OVERALL LANDSCAPE PLAN

FUEL CHURCH PROJECT
16965 LINDBERGH ROAD
EL PASO COUNTY, COLORADO

SHEET NO.
L1.1

Landscape Plans_V1.pdf Markup Summary

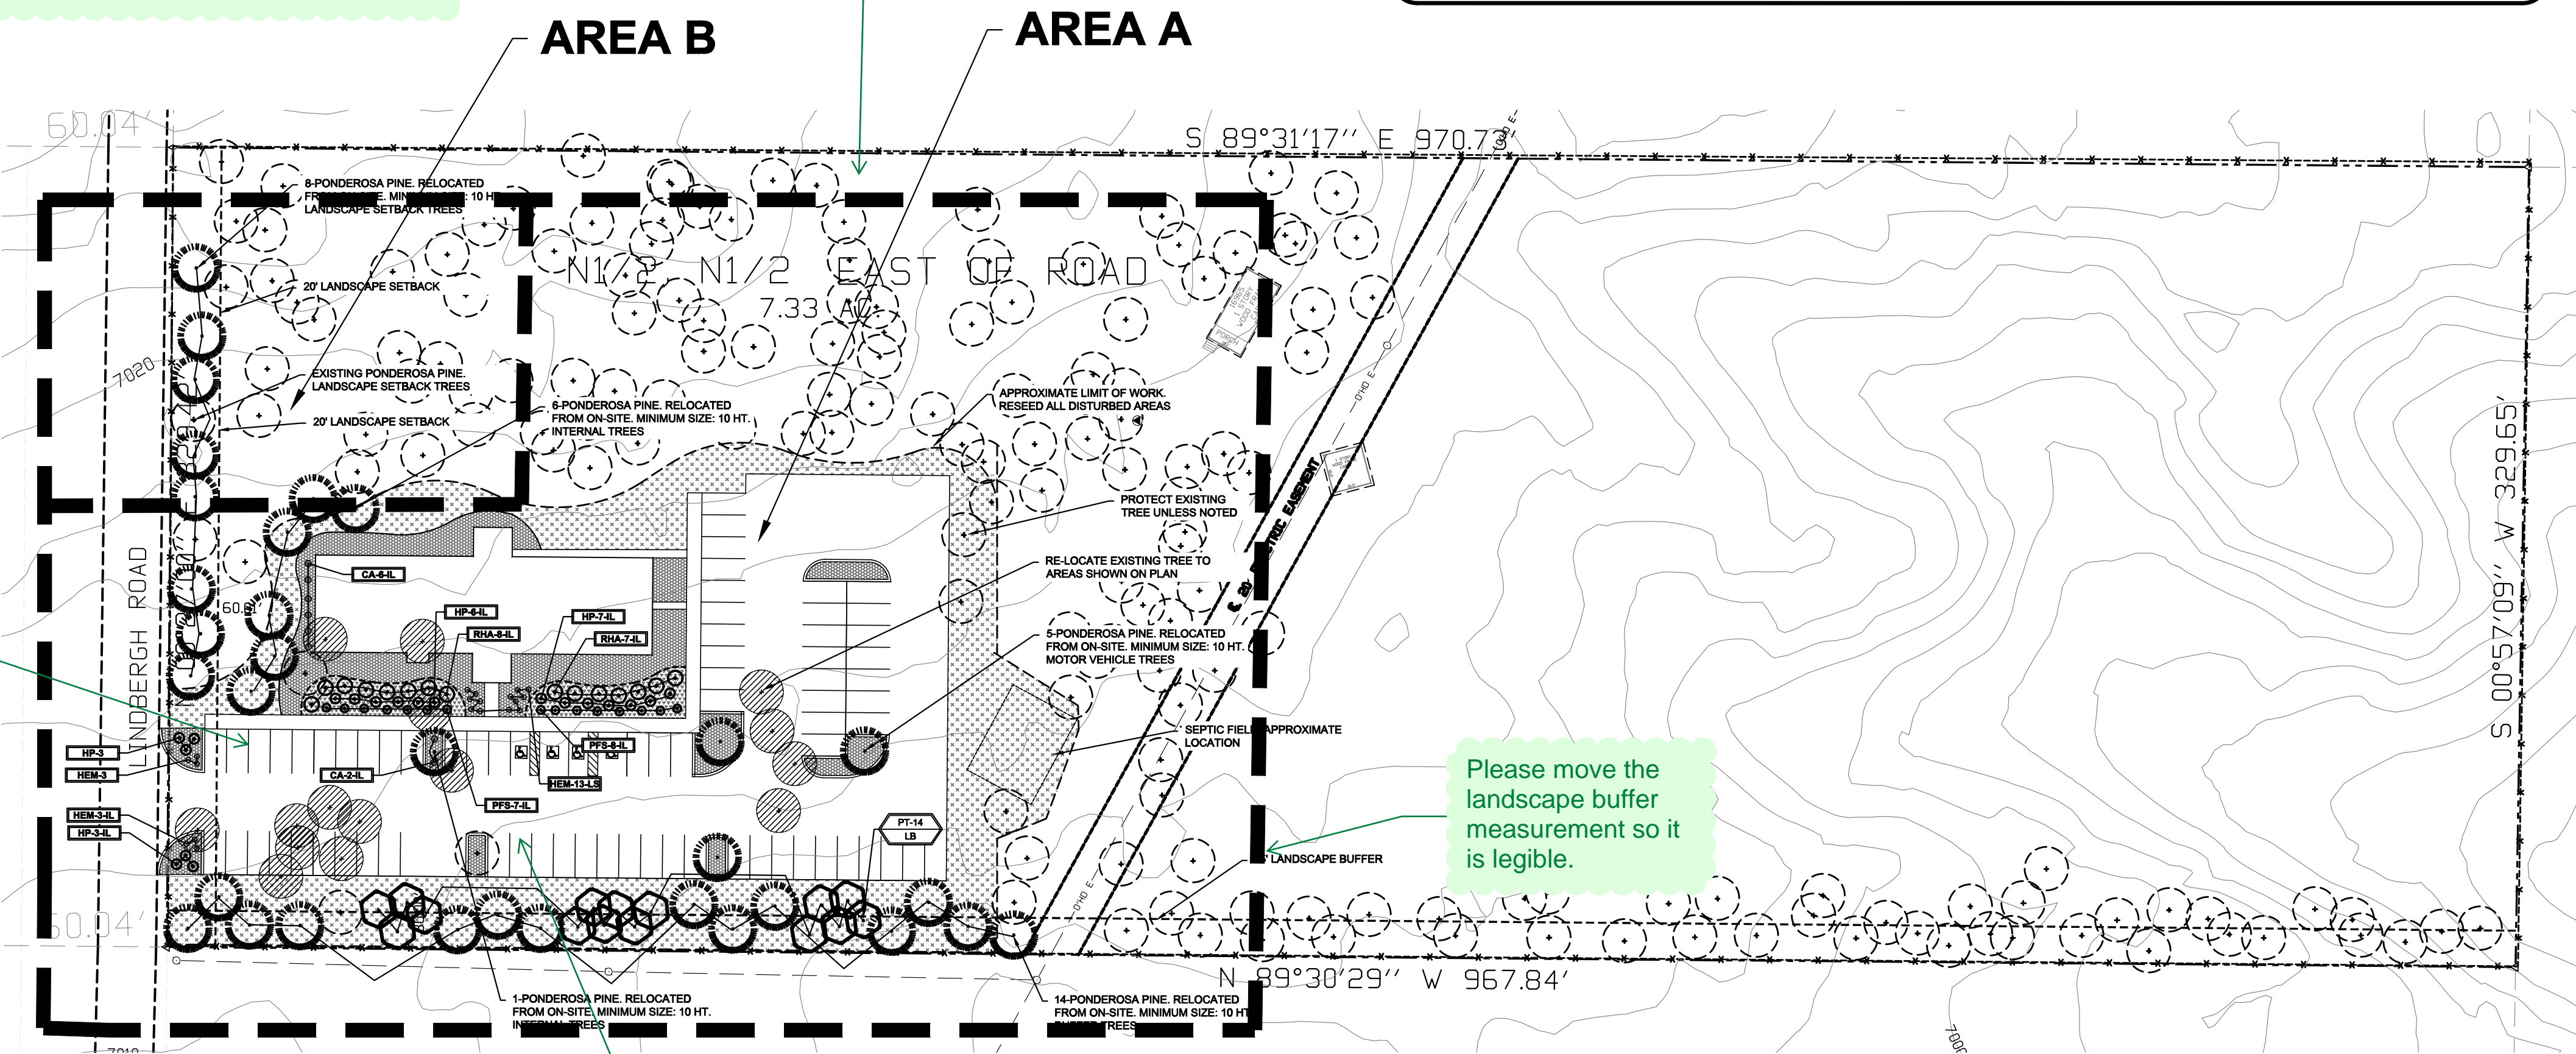
Please note and revise per the following applicable standards:

The required buffer shall be a minimum of 15 feet deep. The minimum number of trees in the buffer shall be 1 tree for every 25 feet of common lot, parcel, or tract line. A minimum of 1/3 of the trees shall be evergreen trees.

An opaque fence or wall with a minimum height of 6 feet is required along the lot, parcel, or tract line except where the adjacent single-family or duplex residential zoning district or use abuts a required roadway landscaping area.

62 spaces provided per site development plan.

5 trees required per parking lot landscape requirements.

Please revise to 970.73 linear feet.

Please show measurement of required buffer

This row of parking does not match the site development plan, either. Site dev. plan shows 4 parking spaces west of ADA spaces. Also, this row of parking has 4 more spaces than are shown on the site development plan.

Please move the landscape buffer measurement so it is legible.

Parking area (islands on southern parking row) is inconsistent with the site development plan. Please revise site development plan/landscape plan to ensure consistency.

14 trees required per buffer between nonresidential and requirements for minor arterial (329.42 linear ft. / 25 = 13.17 trees required along road frontage).

A minimum of 1/3 of roadway landscaping trees shall be required per roadway landscape requirements

If Code requirements shall not be met and an alternative landscape plan is requested, then please include justification of that in the letter of intent by explaining how the proposed landscaping meets the purpose of the code and promotes the concepts contained in the Landscape and Water Conservation Manual.
